Prepared for:
NSW Department of Education

Submissions Report (SSD-23512960)

Glenwood High School

Figure 5 Proposed shrub planting (outlined in red) to the west of the outdoor condenser unit (outlined in blue)

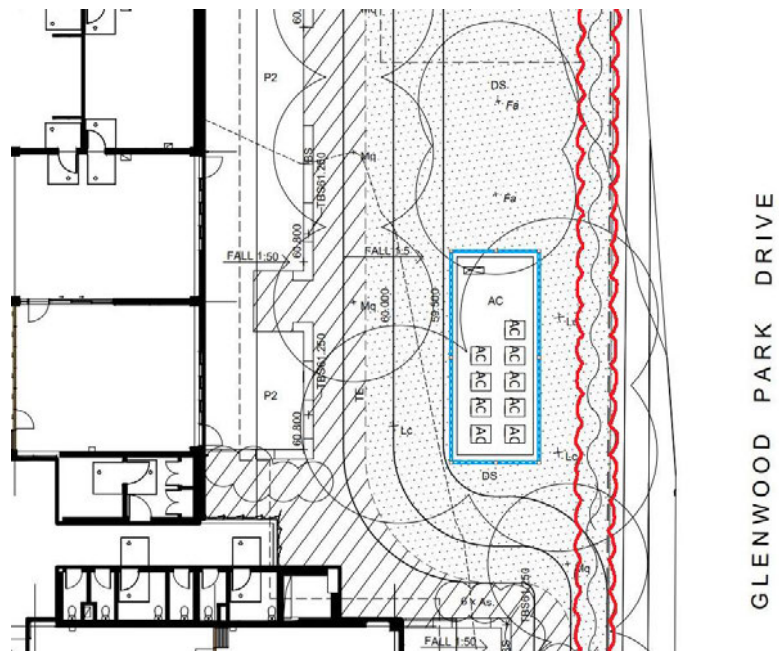
To achieve the noise emission criteria, the proposed 2.5m high noise barrier to the eastern side to the outdoor condenser units located to the east of Building N East would need to increase to more than 3 metres in height. The proposed barrier is shown in **Figure 4** below.

It should be noted that the shrub planting with a height of 3 metres (Lilly Pilly) is proposed to the east of the outdoor condenser unit along Glenwood Park Drive.

This would not be sufficient to visually screen an acoustic barrier of 3 metres and higher. Refer to **Figure 5** below.

Furthermore, it is considered that such a barrier may impact solar access to the proposed new buildings and may require significant reinforcement to provide sufficient wind loading. In this case, given that the impact of 2db(A) is imperceptible to the average listener, strict compliance with the noise emission criteria is considered unreasonable and unnecessary.

This approach is consistent with EPA's Noise Policy for Industry (NPfI) 2017, which does not require strict compliance subject to suitable justification and assessment of the acceptability of residual impacts. Notwithstanding, it is noted that the assessment presented in the NVIA was a worst-case scenario and where possible, quieter building services plant would be selected during the detailed design.

Figure 8 Excerpt from Landscape Report showing modifications to the bleacher seating around Tree 73

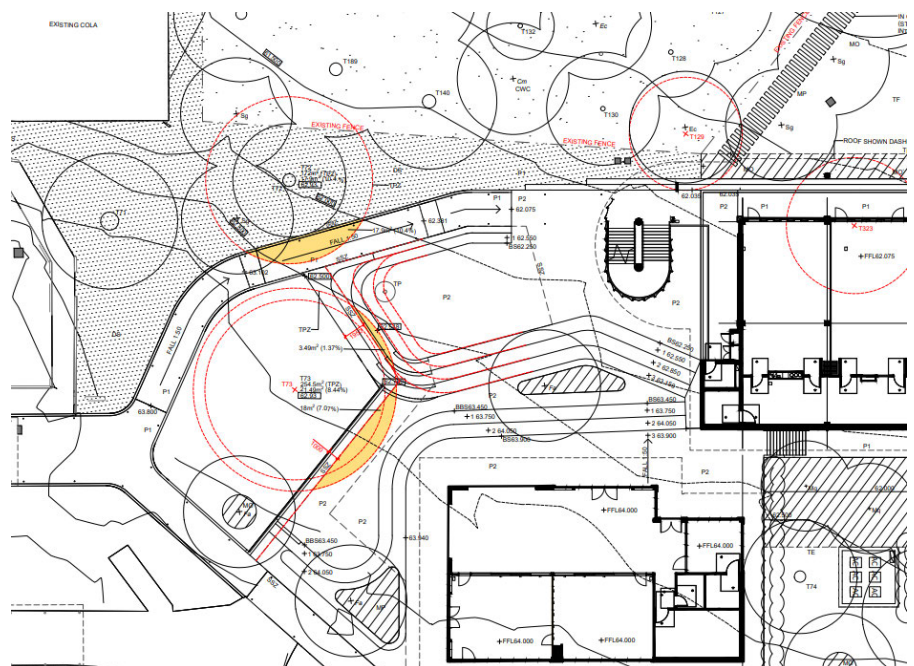
- Tree 73: is detailed to be subject to high impact from the proposed development. However, the exhibited AIA identified that there is a possibility for design changes which could allow for the retention of this tree. It is therefore recommended that the potential for this tree to be retained and protected is further explored.

Tree 73: The Arborist Report which accompanied the EIS at **Appendix T** identified that this tree would be subject to high impact (>20% TPZ encroachment) because of the SSD works; hence, the tree could not be retained without design changes.

In response, design changes have been made to the SSD works to reduce the level of encroachment into the TPZ due to SSD works. The TPZ encroachment has been reduced from 20% to 8%. Refer to **Figure 8** below.
